STAFF REPORT: NOVEMBER 16, 2022 MEETING

APPLICATION NUMBER: 22-8103

ADDRESS: 2475 CHICAGO

SCOPE: INSTALL ALUMINUM RAILINGS & SLIDING DOOR, INSTALL VINYL WINDOWS AT REAR DORMER (*WORK COMPLETED WITHOUT APPROVAL*), REVISION OF PREVIOUSLY APPROVED ERECTION OF REAR TWO-STORY PORCH (*WORK COMPLETE*), REPLACE WOOD WINDOWS WITH VINYL & GLASS BLOCK WINDOWS,

2019 applicant documents

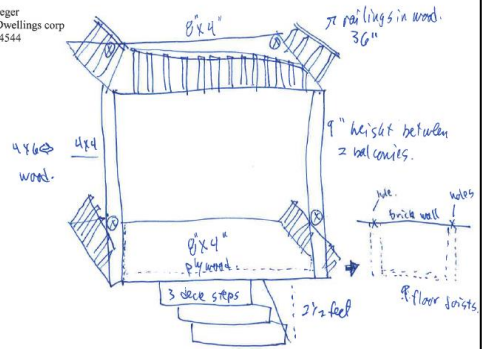
- There is no record of the applicant submitting construction documents to staff for review, nor was a building permit issued.
